**REGULAR MEETING OF THE
CITY OF ALVARADO PLANNING AND ZONING COMMISSION
104 W. COLLEGE AVE.
MAY 16, 2024
6:30 PM
AGENDA**

This letter is to inform you that the attached Lone Oak Addition Phase 1 final plat application provided on April 22, 2024 has generated the recommendation of disapproval from the Alvarado Planning and Zoning Commission due to the following comments not being adequately addressed to result in compliance with the Alvarado subdivision ordinance.

ENGINEERING PLANS
FOR
LONE OAK PHASE 1
CITY OF ALVARADO
JOHNSON COUNTY, TEXAS
MARCH 2024

City Engineer Remarks on Preliminary Plat and Preliminary Engineering

- STORM SEWER
- STORM SEWER MANHOLE
- SANITARY SEWER LINE
- SANITARY SEWER MANHOLE
- WATER LINE & VALVE
- FIRE HYDRANT

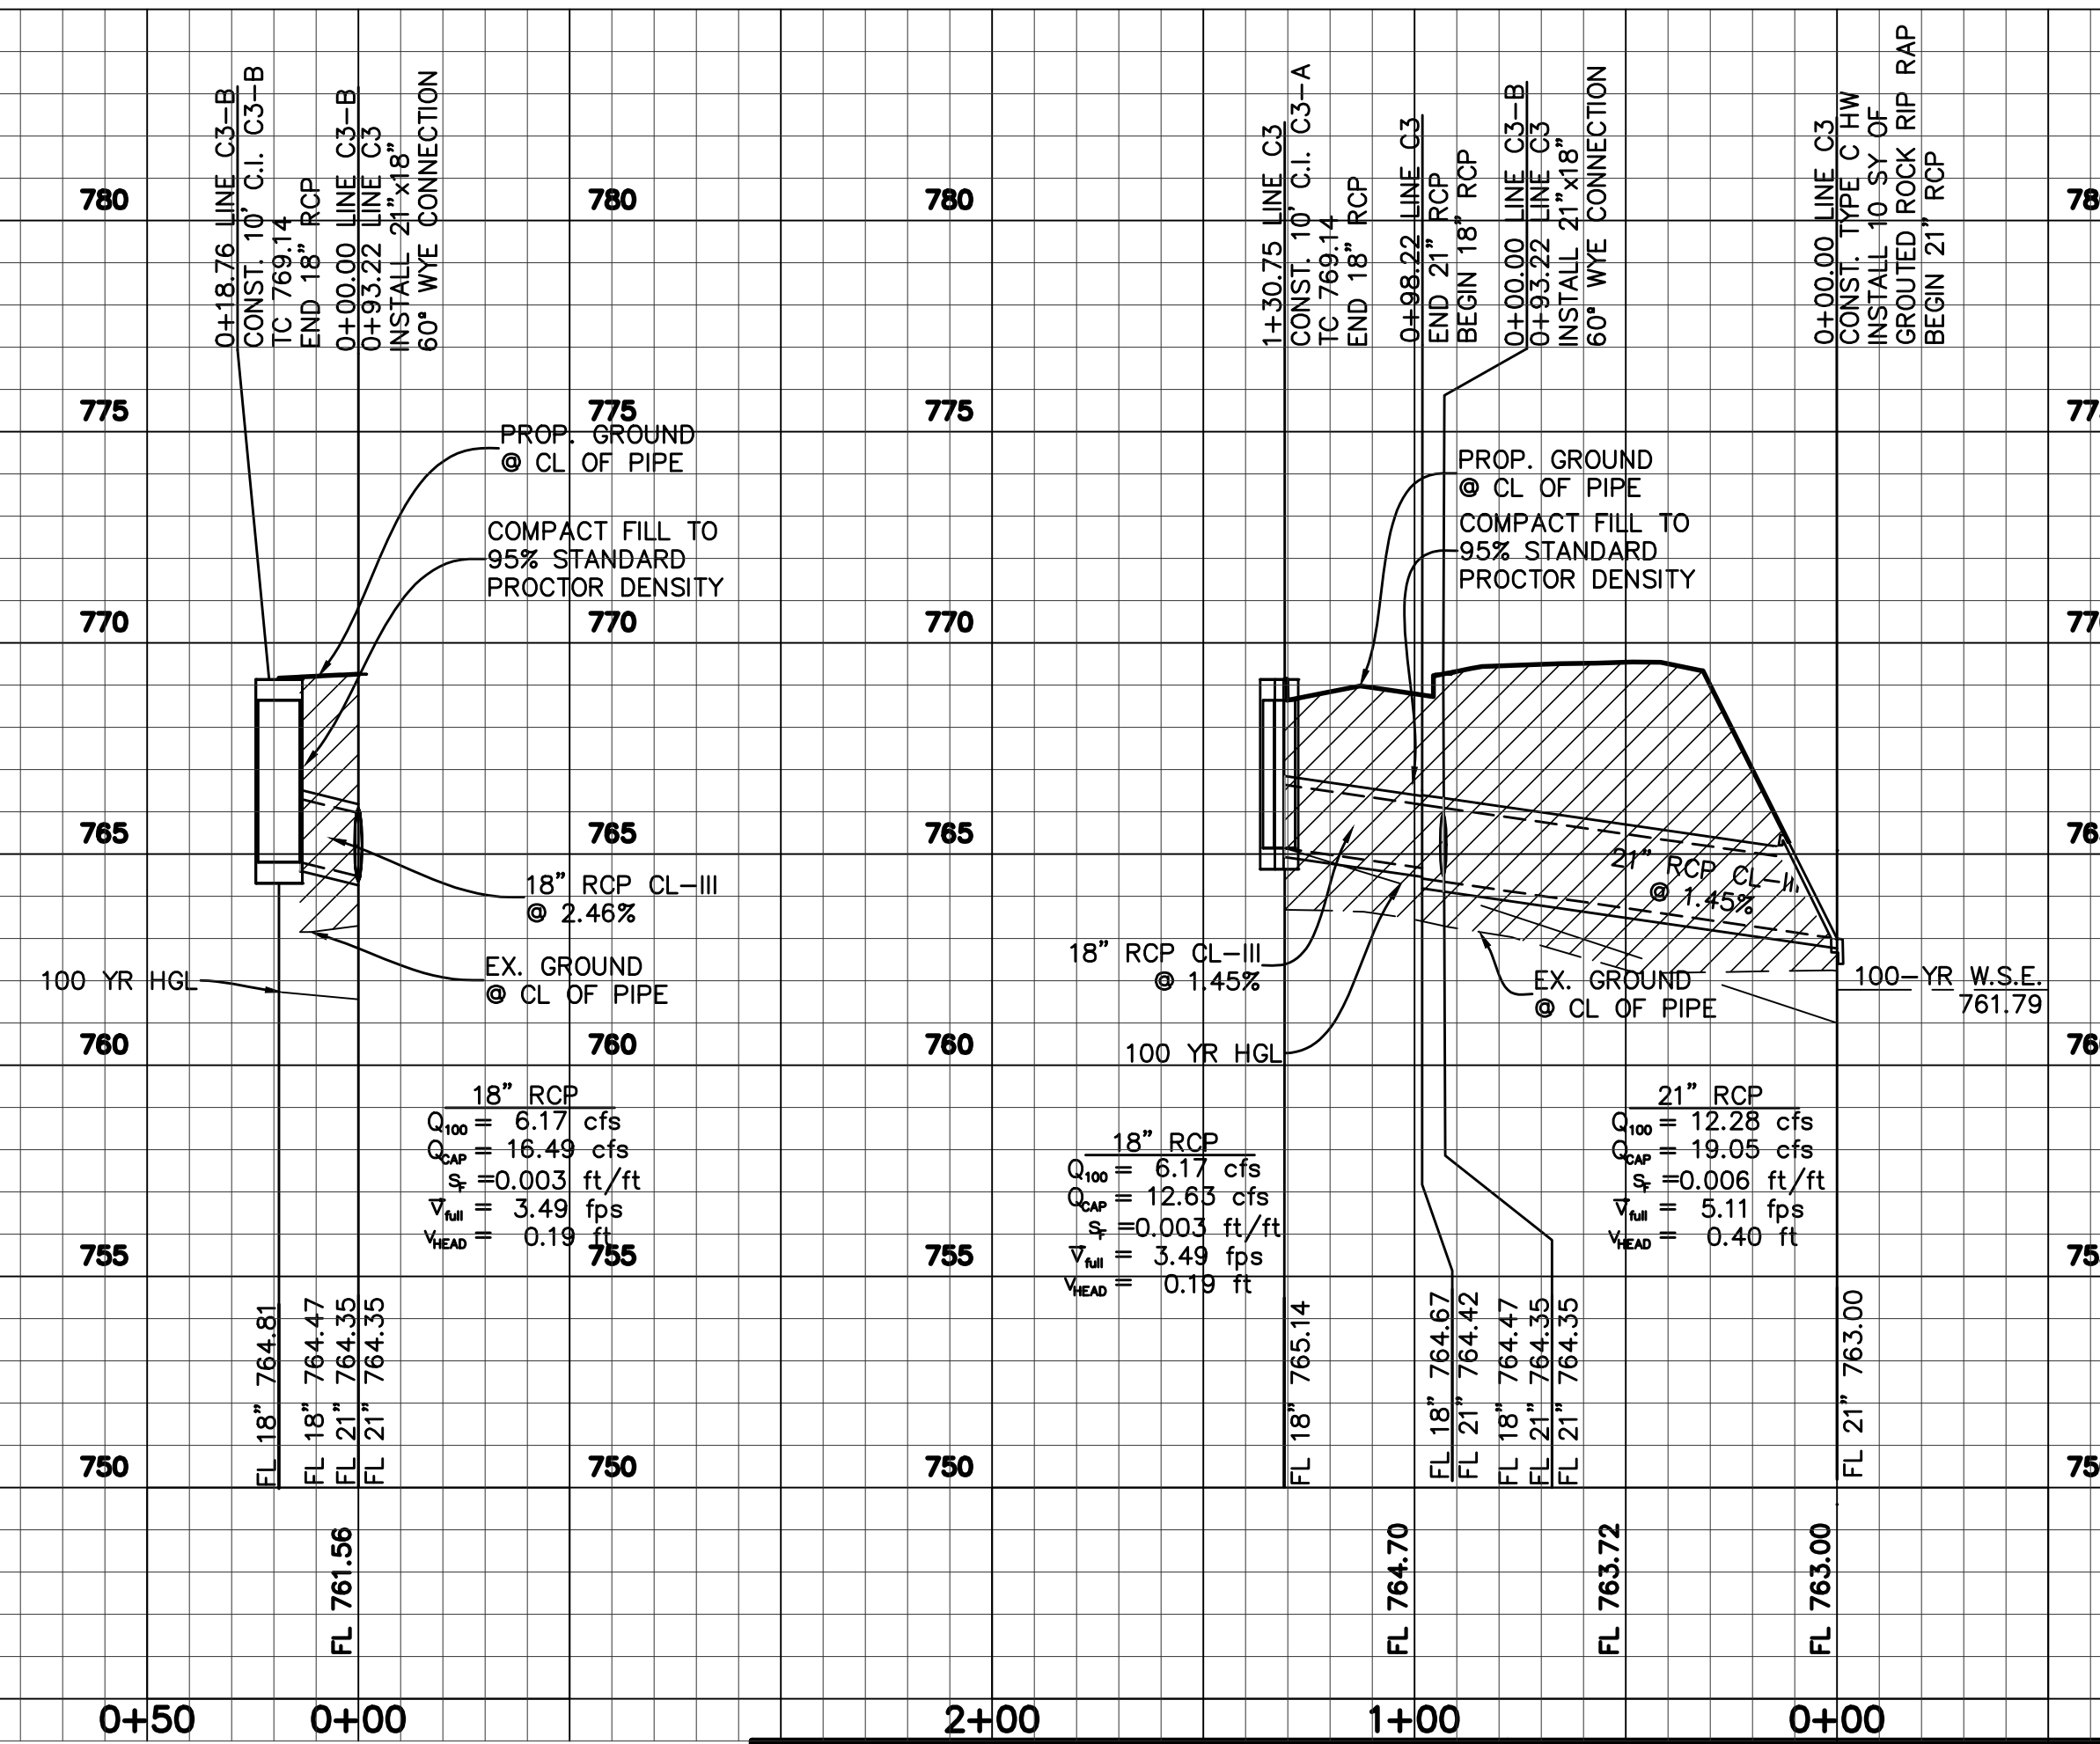
Exceed maximum discharge velocity

SANITARY SEWER		PROJECT NO.
FM-1 ST. 0+00 TO ST. 9+50		BBC010
LONE OAK, PHASE 1		SHEET NO.
City of Alvarado, Johnson County, Texas		7.17

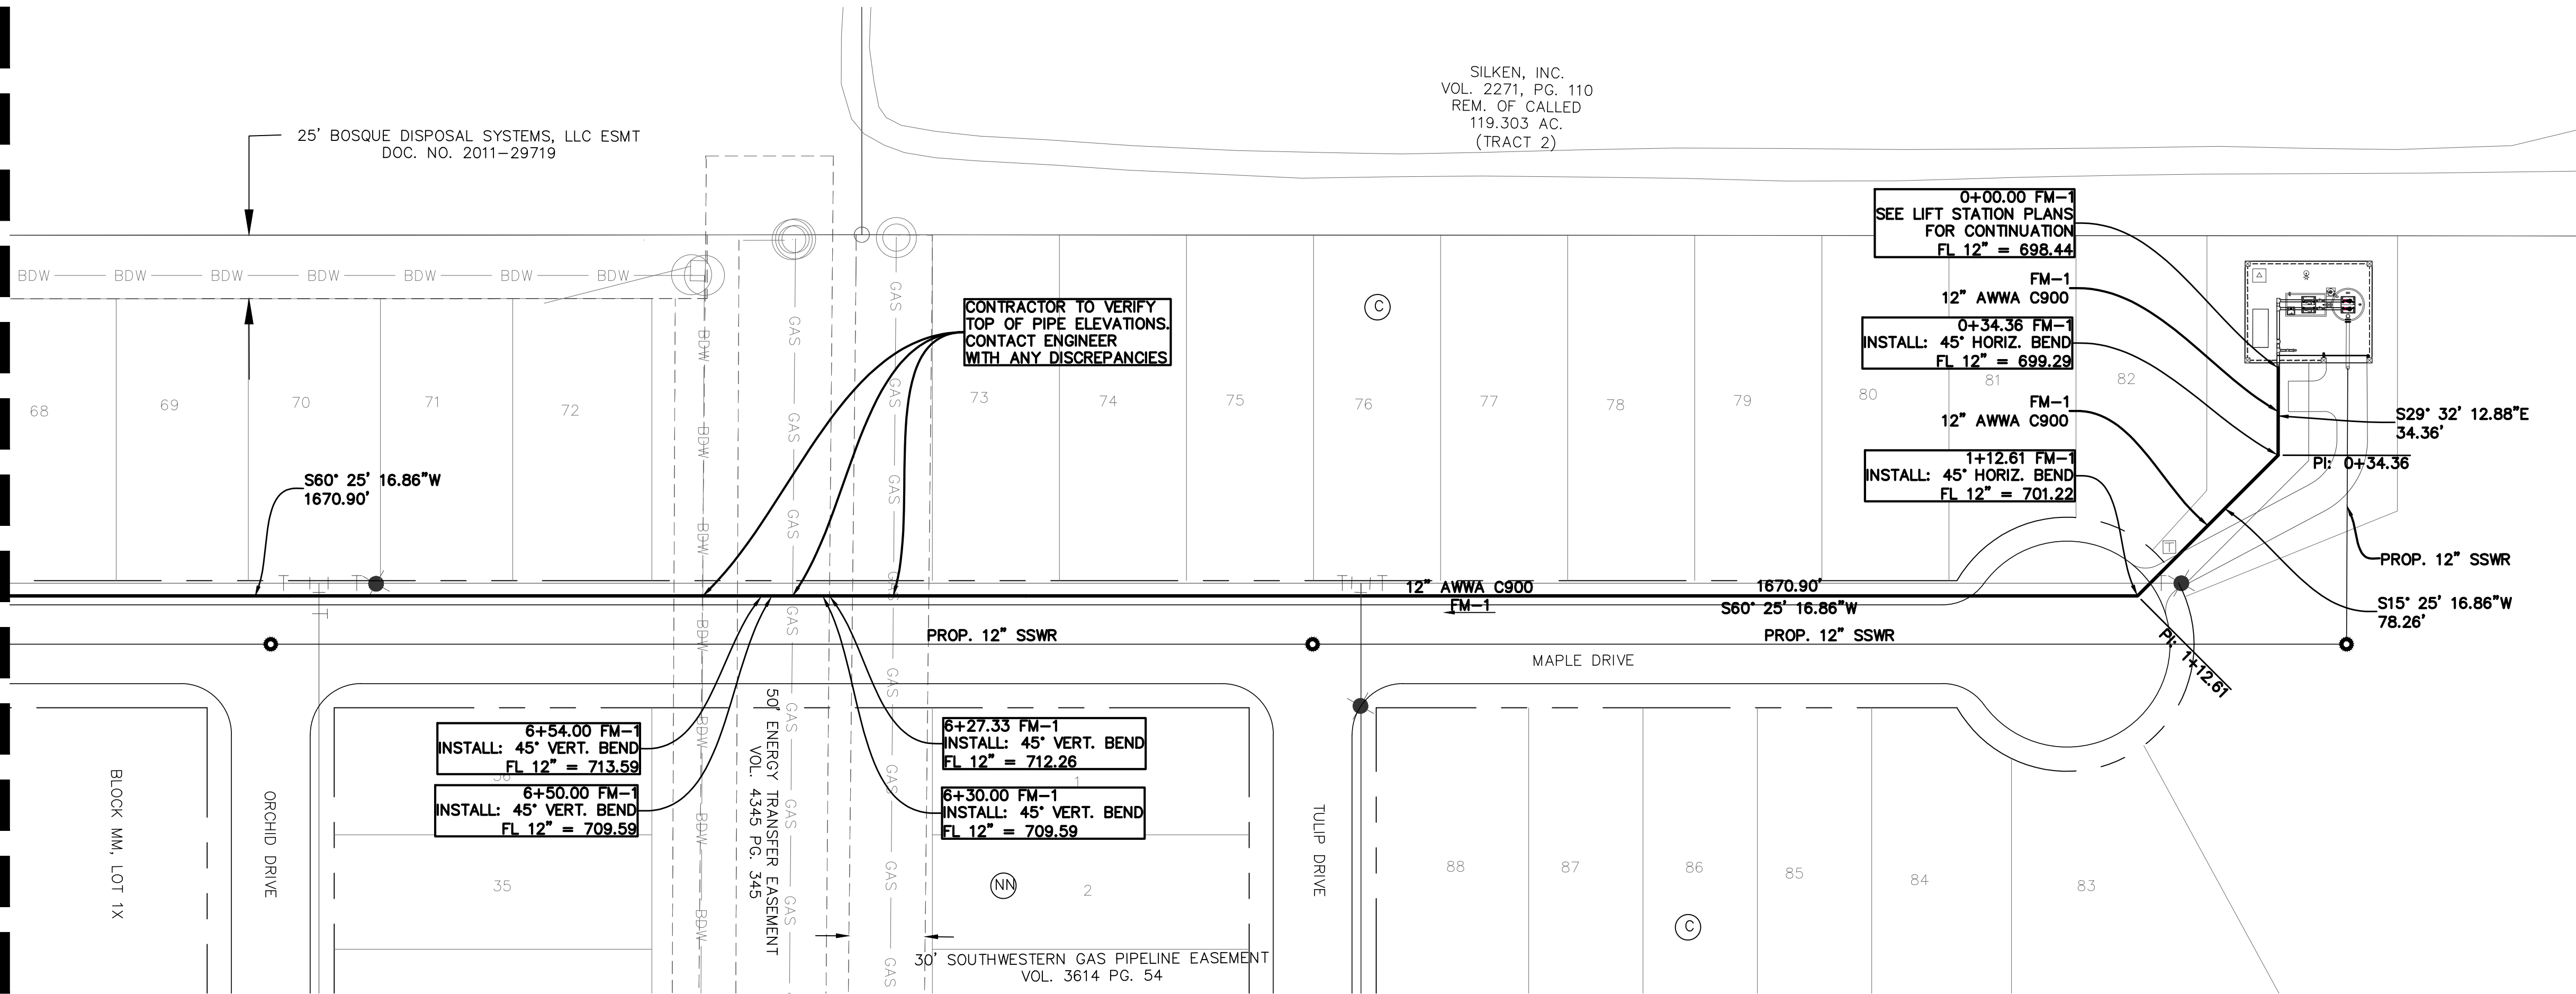
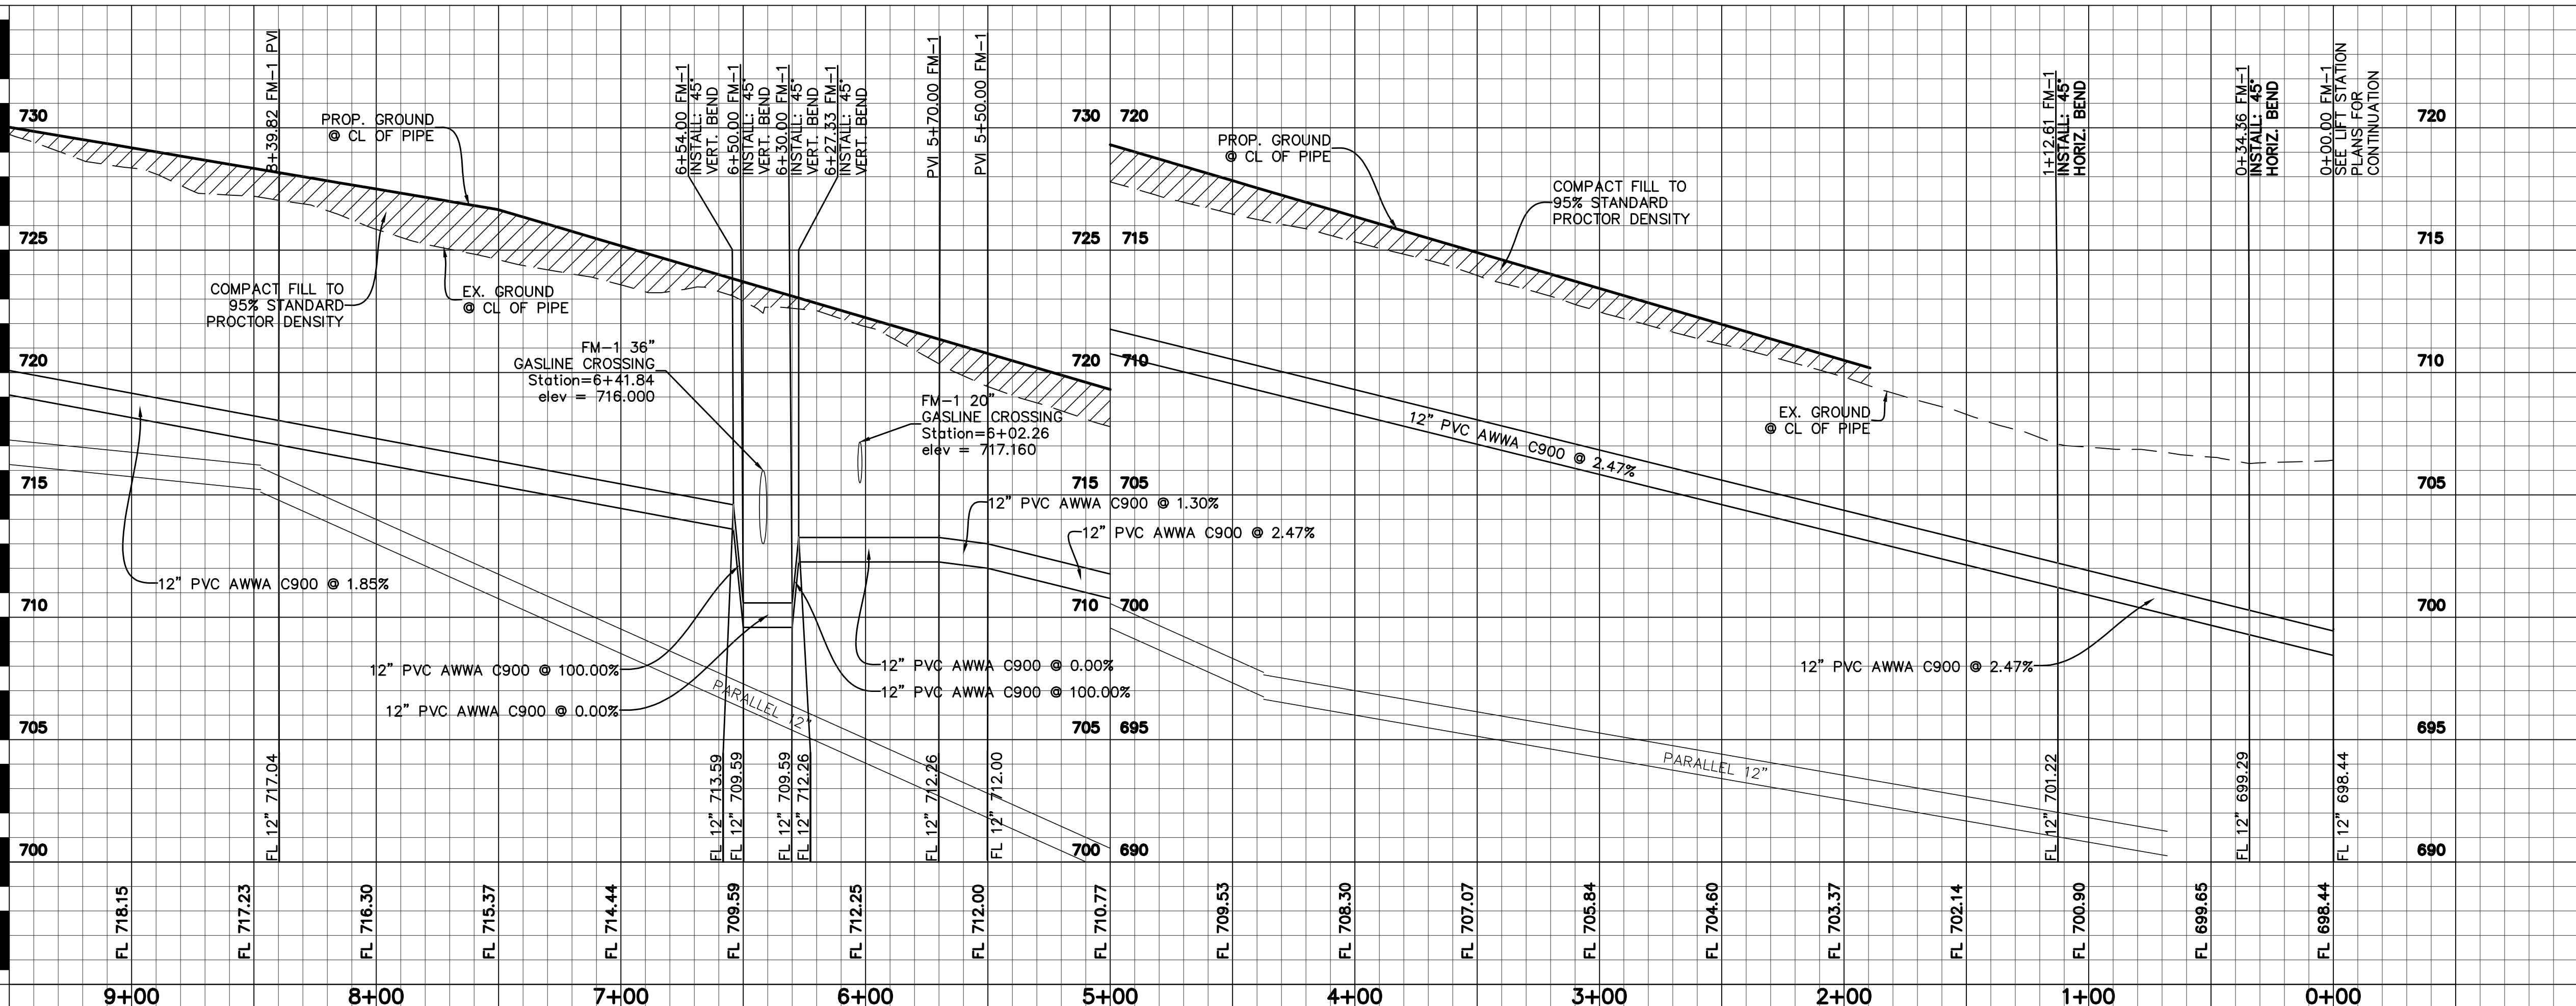
Force main sizing will be confirmed with the lift station review

ENGINEERING PLANS
FOR
LONE OAK PHASE 1
LIFT STATION
CITY OF ALVARADO
JOHNSON COUNTY, TEXAS
APRIL 2024

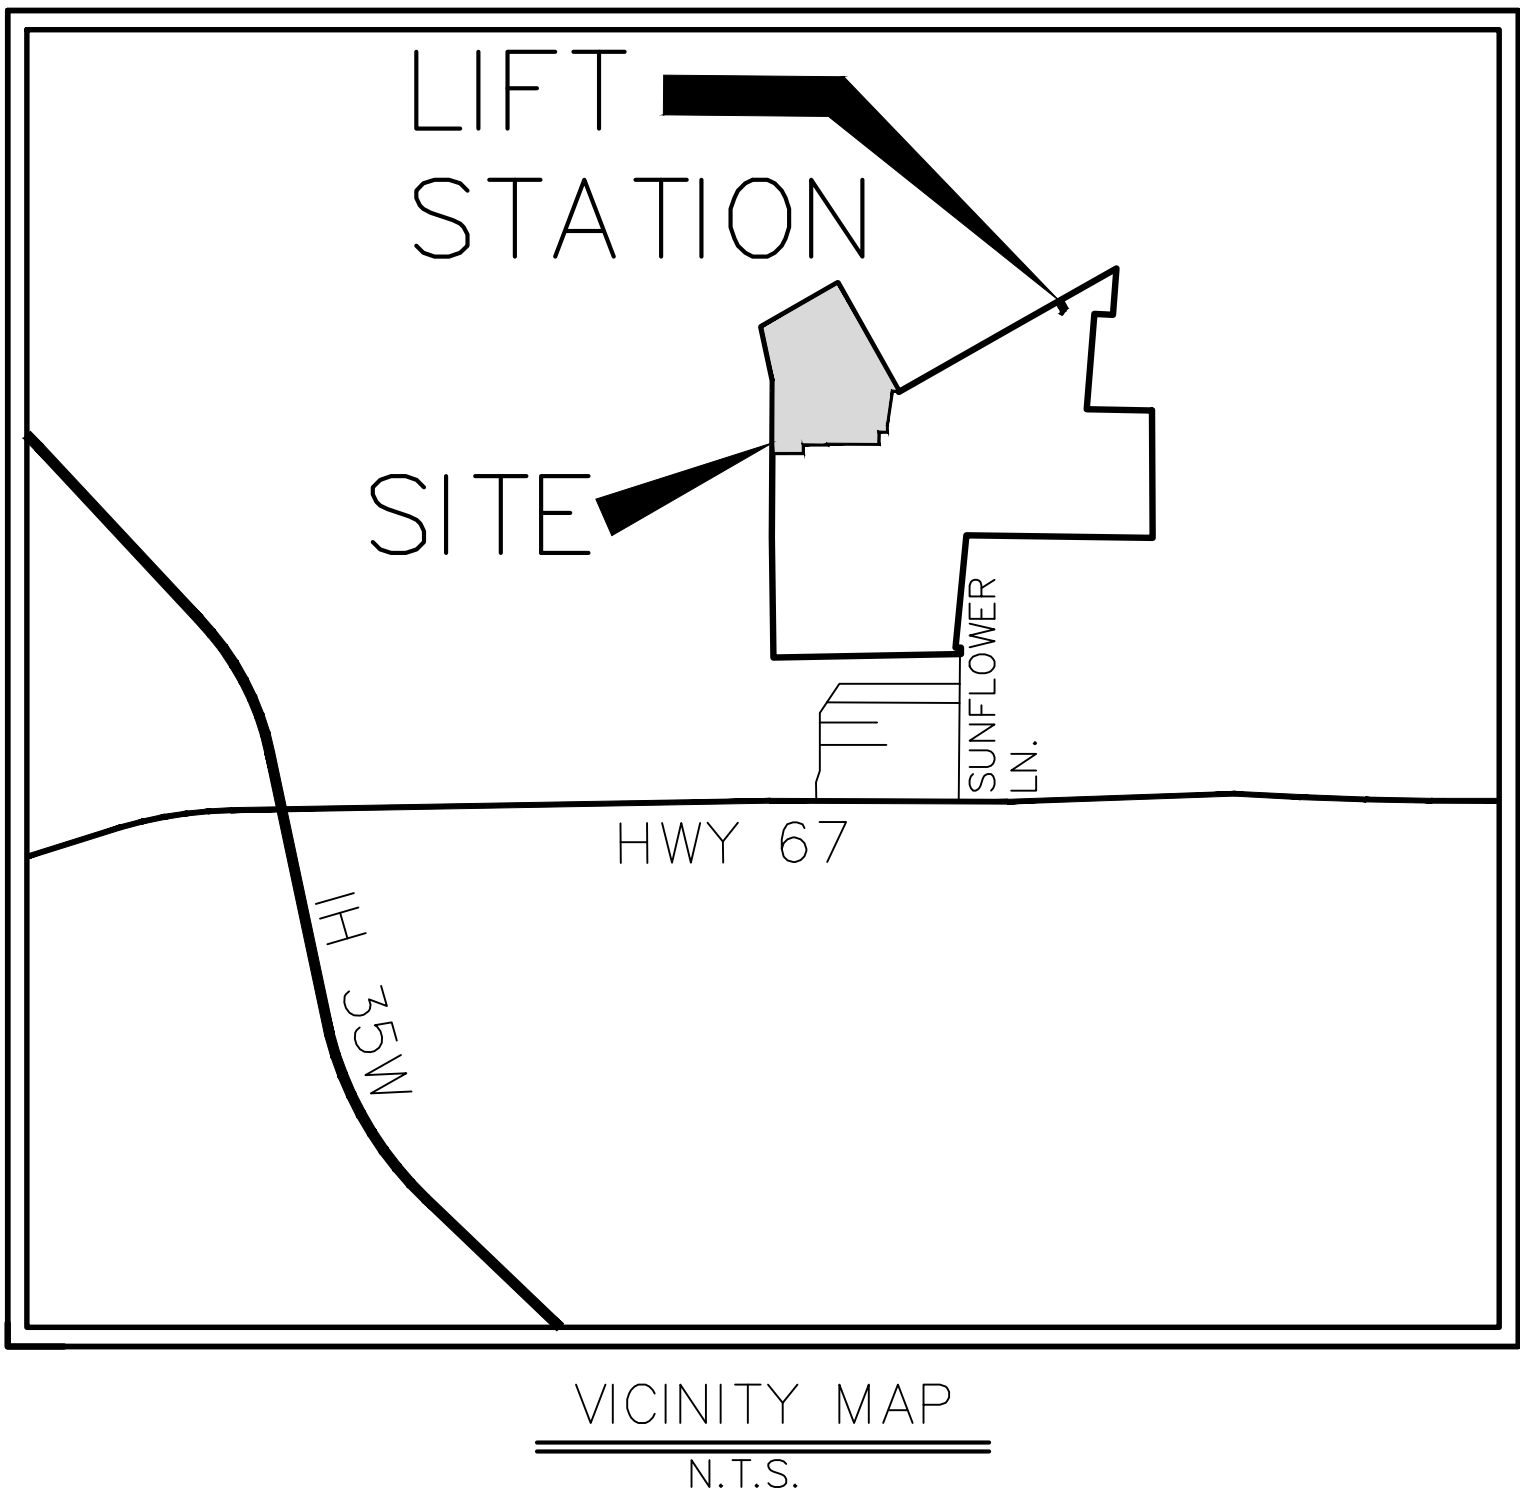
Downstream capacity is limited in the existing SS system. Improvements cannot be accepted by the City prior to downstream capacity being provided or an alternate agreement with the City.
